R09PL

# Headlining Rivets

# RECALL

**MODELS AFFECTED:** 2010 D3FE All American School Buses manufactured at Fort Valley, Georgia from January 19, 2009 through May 13, 2009.

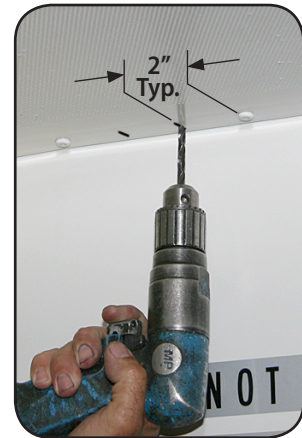
On some units, the rivet spacing may be incorrect in some segments of the rear headlining and rear upper inner panel joint, resulting in noncompliance with FMVSS 221, School Bus Body Joint Strength.

- 1** Park vehicle on level surface, apply parking brake, remove ignition key and chock wheels.
- 2** Inspect rivet spacing at rear headlining and rear upper inner panel joint. Joint must have a minimum of four rivets in an eight inch segment.
  - 2.1 Place the template over the joint and parallel to the edge of the headlining panel, allowing roof rivets to be exposed through the opening in the template as shown.

Inspect the rivet spacing at the joint and install additional rivets as required by specification.

- 2.2 Move the template from one side of the headlining panel to the opposite side.
- 2.3 If a segment in the rear headlining panel joint contains less than four rivets, additional rivets are required. Mark each area that requires additional rivets. Rivets should be spaced on approx. 2" centers.
- 2.4 If additional rivets are required; add additional rivets between the largest spaces until a minimum of four (4) rivets have been added in the 8 inch segment.

- 3** Using a short 7/32" drill bit, drill a hole through the headlining panel and the rear upper inner panel. Be sure to drill hole on a common center-line with existing rivets.

- 4** Install pre-painted rivet/s in each hole.
